Date: 02 May 2025

Respond to Request Further Information 2 September 2024

Private Plan Change Request (Ref: PC0003/23) – Coniston Park Ltd, Farm & Racecourse Roads, Ashburton

Note: Isolated pockets of deep water may be due to elevation discrepancies in the LIDAR surface.

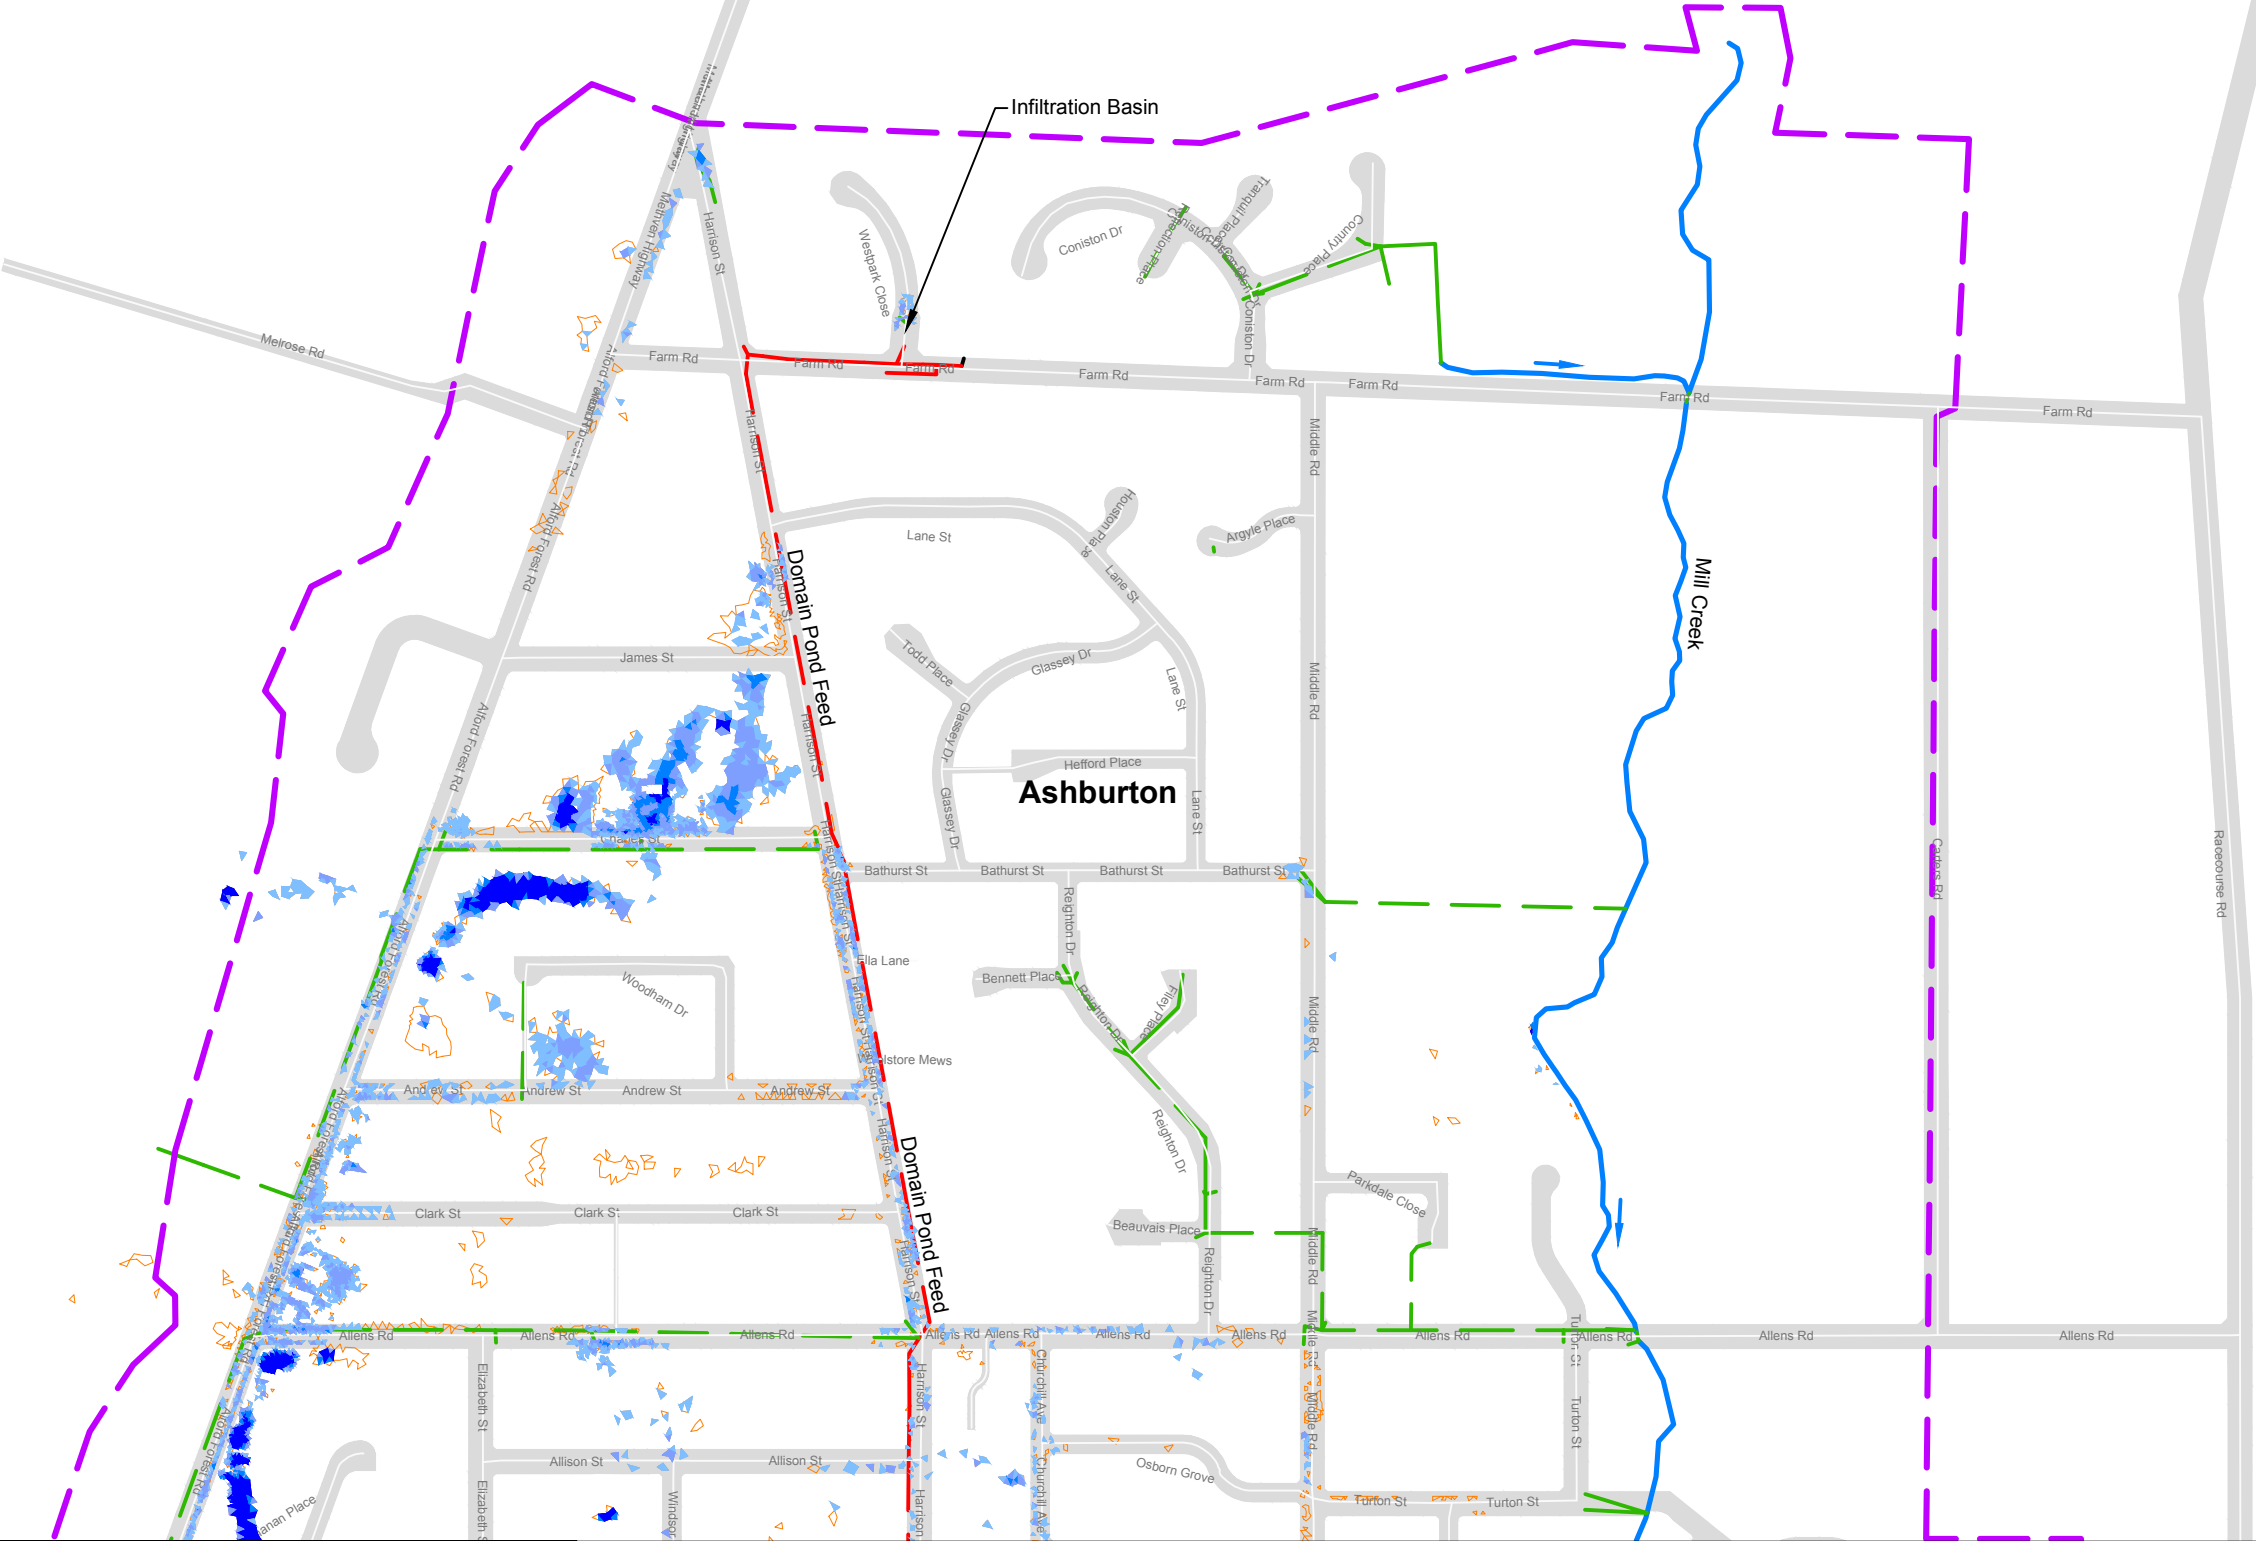
- **Future design for the waterway will need to look at culvert(s) crossing the Wakanui Creek and the flood capacity of the waterway.**

The stormwater design for the post-development discharge is no greater than pre-development for all rain events up to 2% AEP 48hr duration and therefore is not required to do so.

According to Ashburton Urban Stormwater Strategy Hydraulic Modelling Plans (Feb 2015) supplied by ADC the culvert across Farm Road and the stream maintains the flood water within Wakanui Creek both upstream and downstream of the culvert. This demonstrated there is sufficient flood capacity within the area.

Please refer to Ashburton Urban Stormwater Strategy Hydraulic Modelling Plans (Feb 2015) in Appendix D for the 10%, 2% and 1% AEP 48hr duration model output plans.

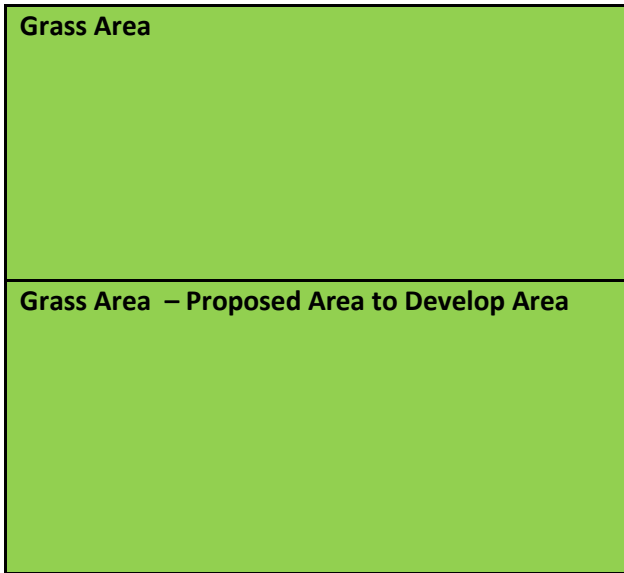
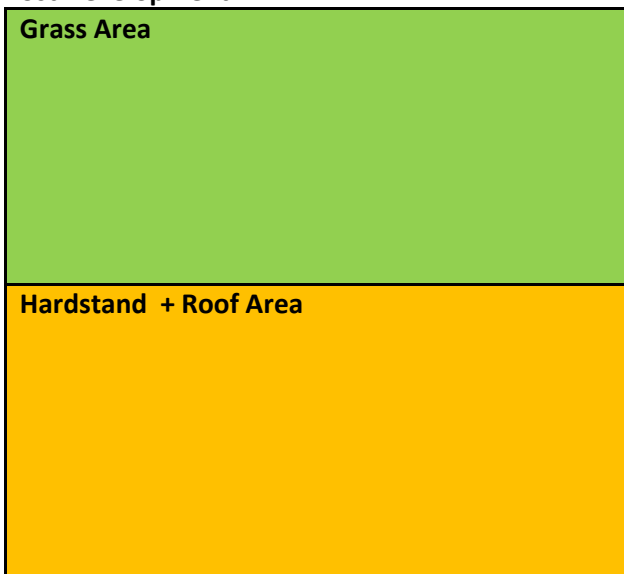
- 2) The formula mention in (1) also come downs to how this is going to be applied.

If this is covering the whole area (including grass) as weighted attribute. Does this mean the area the grass (both the reserved, garden in each allotment) will need to attenuate 20% more even though it was grass surface initially? It is reasonable to be applied for small and medium development, but large development where there are large grass areas then the volume to attenuate grass area is going to be confirm? Example as below
